ADDENDUM NO. 2

Date: December 30, 2011

Project: **CIVIC CENTER NORTH PUMP STATION AND
JOHN DUCKETT PUMP STATION
STANDBY GENERATOR REPLACEMENT PROJECT**

Job No.: 10300-11/-09

ADDENDUM SKETCH 7970-ADD2-A

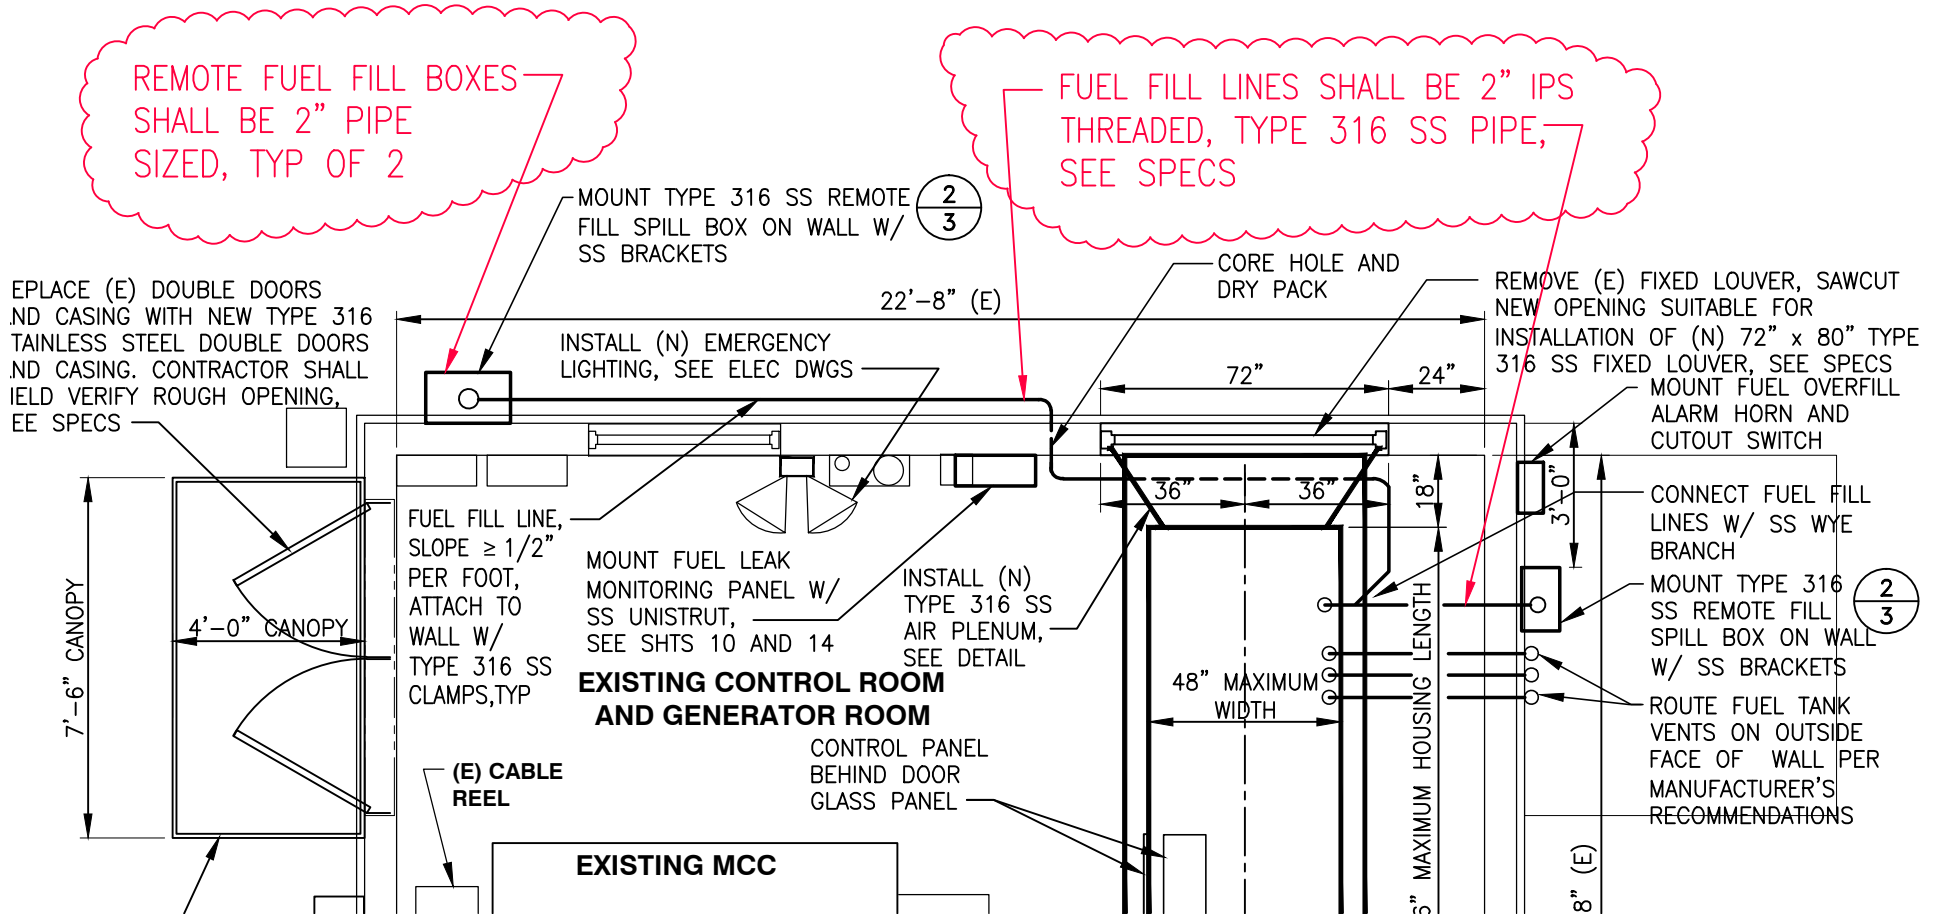
1. Sheet 3 of 18 CIVIC CENTER NORTH PUMP STATION FLOOR PLAN, SECTION AND DETAILS

The attached Addendum Sketch 7970-Add2-A shall modify sheet 3 of 18.
